**CITY OF FREDERICKSBURG
HISTORIC REVIEW BOARD
TUESDAY, MAY 11, 2021
5:30 P.M.**

7. CERTIFICATE OF APPROPRIATENESS APPLICATIONS

Application Number: 21-44
Date: May 11, 2021
Address: 207 W San Antonio
Zoning: CBD
Owner: West End Pizza
Applicant: Andy Bray of Mustard Design
Rating: High
Proposed Modifications: installation of railing on porch

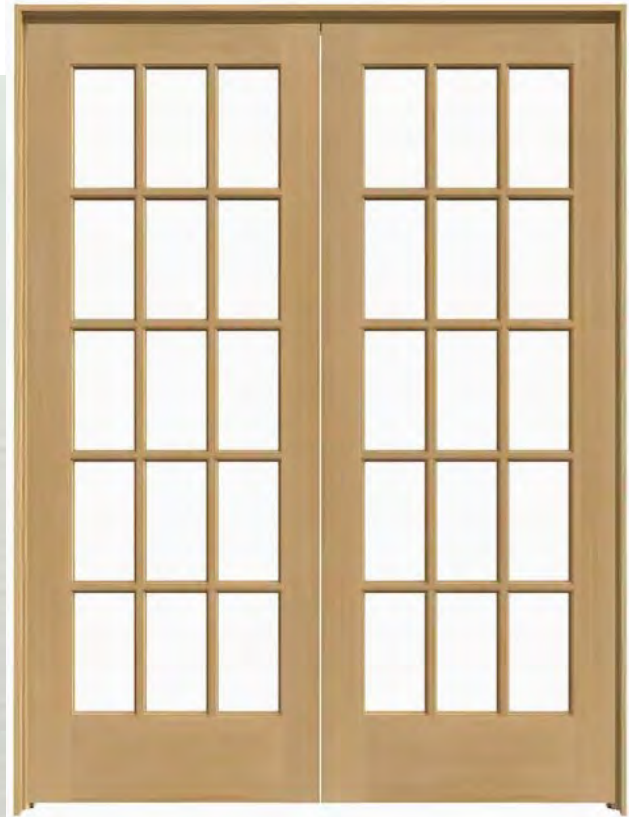
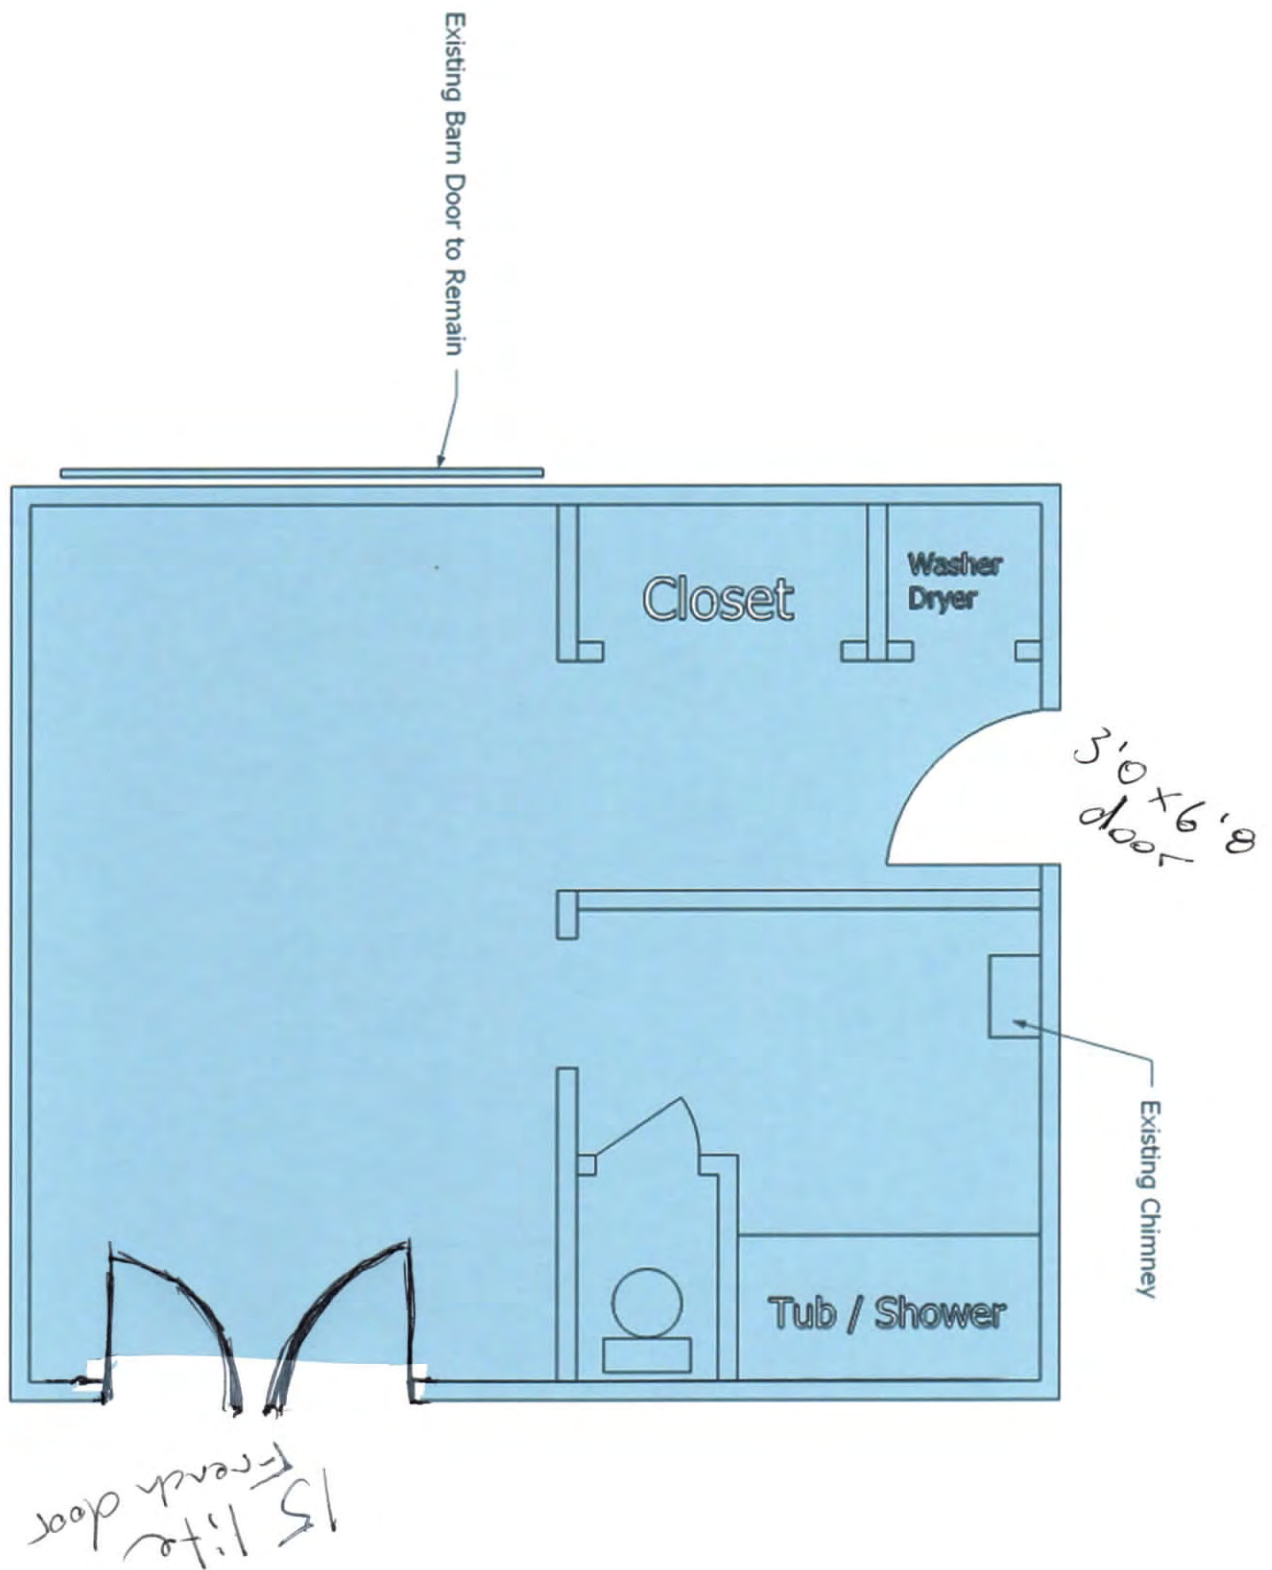
Location of new French Door

Location of new door to give access to main house from garage

Proposed Battens

The proposed changes to the garage will ensure it is continued to be used. The battens are needed to improve energy efficiency and add structural stability. The batten design is very common for the time period. The proposed new doors are not readily visible from the street.

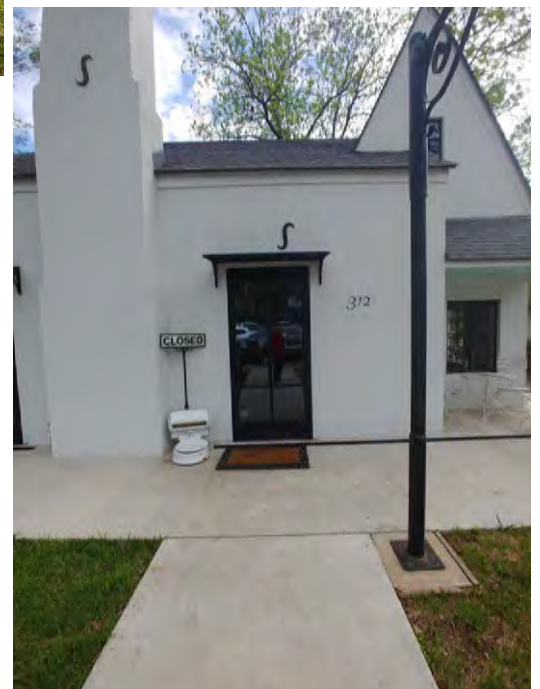
Scored concrete to look like
brick

Two aluminum windows to be replaced to match original windows

Proposed finished look with stucco and black windows. Original metal windows to be repaired and painted.

Front porch in need of repair

The house was given a medium rating in the 2018 survey. The proposals will rehab existing features including windows, roof, and porch. The addition between the main house and garage is not historic, the proposal to replace the windows to match the main house will improve the appearance. The addition of stucco over the existing scored masonry is the biggest proposed change. The scored concrete is a character-defining feature of the house. Staff recommends the concrete be painted instead of stuccoed. This recommendation is based on Secretary of the Interiors Standards for Rehabilitation 5 and 6.

06 GARAGE NORTH ELEVATION

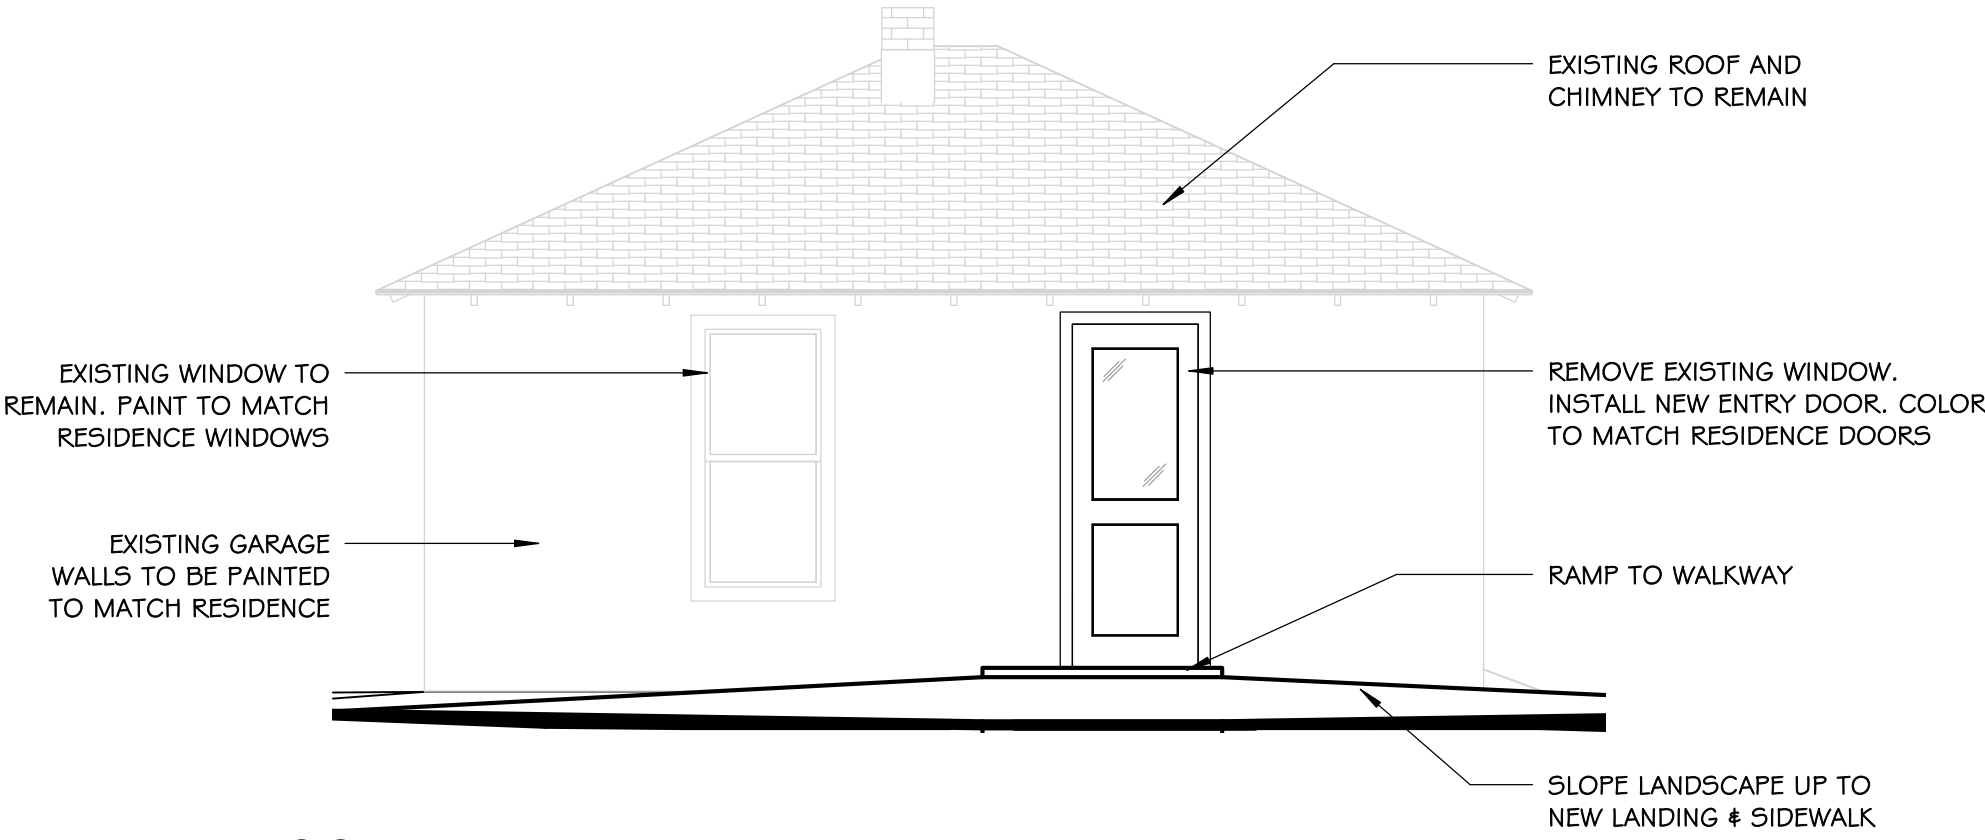
- 5. The garage window is not visible from the street, the change from a window to door will give access to the garage. The original window should be stored one site. Staff recommends approval of the change as presented.
